Service Bulletin No. SB-AG-16

FUSELAGE UPPER LONGERON REPAIR

MODELS AFFECTED: Model S2R-R1820, S/N R1820-001DC
thru R1820-031DC

REASON FOR PUBLICATION: PREVENT POSSIBLE FATIGUE CRACKING OF THE LONGERON

FIGURE 1

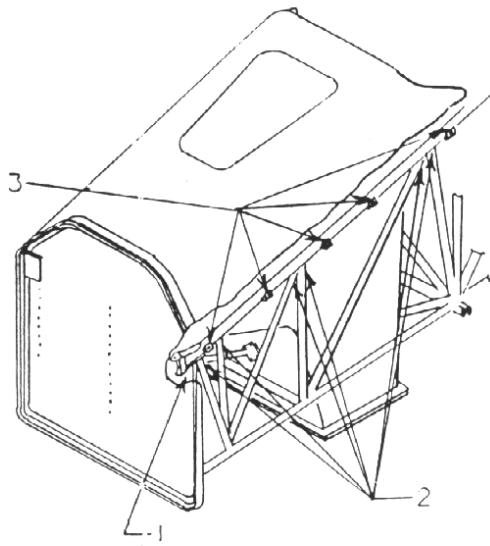
1. Remove the fuselage side skin located between the wing upper surface and the hopper. This will provide access to the upper longeron from the firewall to the cockpit.
2. Visually inspect the longeron paying particular attention to: (See Fig 1).
 1. Area around the upper engine mount attach points.
 2. Each vertical and diagonal tube intersection at the upper longeron.
 3. Each hopper attachment bracket.

FIGURE 2

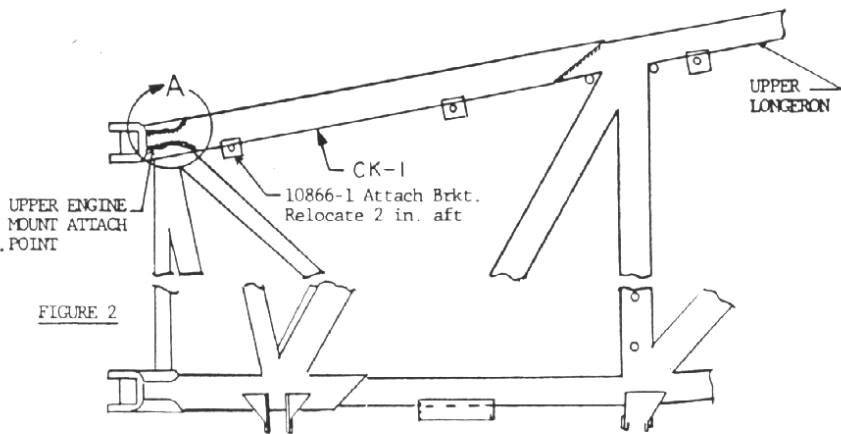
1. If any cracks are found, remove hopper and attaching parts. Weld cracks closed in longerons.
2. Grind off the four 10866-1 Attach Brackets. See Figure 2.

4. Clamp the split sleeves in position and weld as shown in Figure 2.
5. Grind the fiberglass in the hopper saddles as necessary to allow the hopper to be lowered onto the longerons in the original hopper location.

FIGURE 3

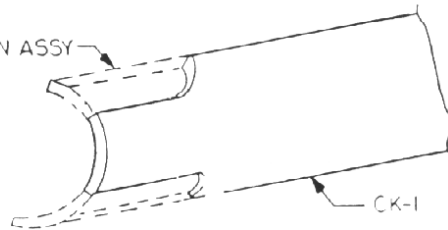
3. Grind or nibble the ends of the sleeve tubes P/N CK-AG-19-1 & -2 to fit snugly within the original weld beads at the forward clusters/gussets at the firewall. See Fig. 3.
